California Water Research comments on WaterFix consistency certification.

These comments are with respect to the Best Available Science requirement in the Delta Plan, and also with respect to whether there is substantial evidence in the record about WaterFix project impacts on the Delta.

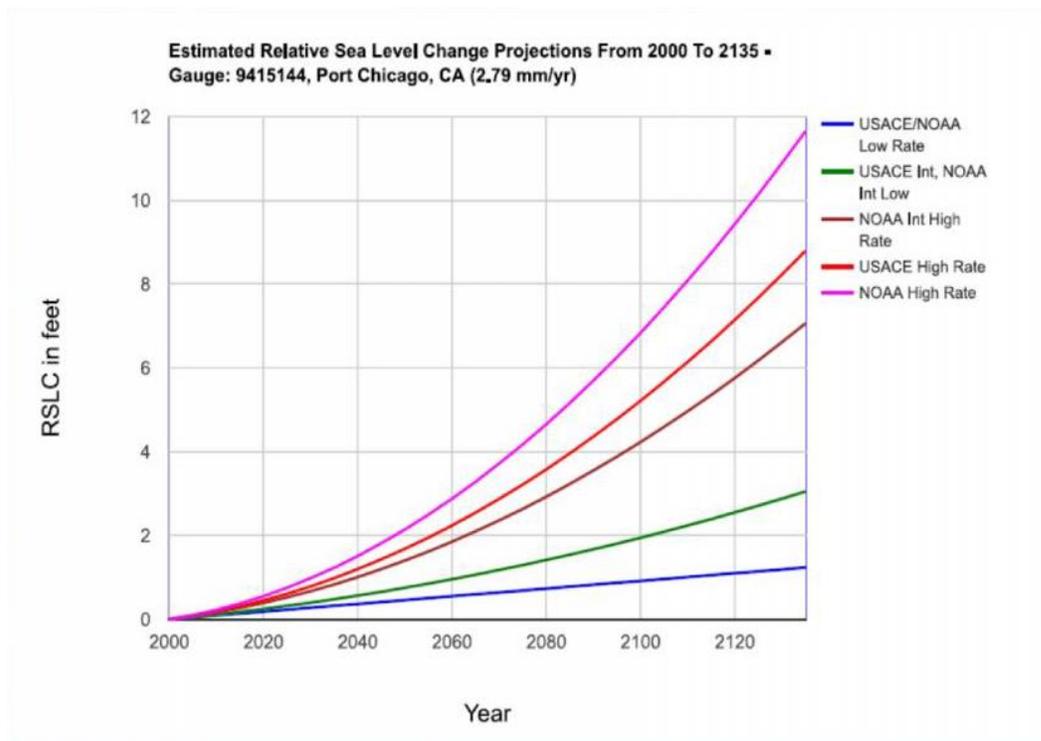
The Ocean Protection Council's high rate of sea level rise is consistent with the NOAA high level of sea level rise, which I testified to in Part 1 of the WaterFix hearing.

The following graph is from the Army Corps of Engineers' sea level rise calculator, and was introduced as Exhibit PCFFA-65 in the WaterFix hearing. The associated table of sea level rise values is Exhibit PCFFA-65 in the WaterFix hearing record. They show that under the NOAA high rate of sea level rise, there could be 55 inches of sea level rise by 2080.

So this may not be a problem for the distant future.
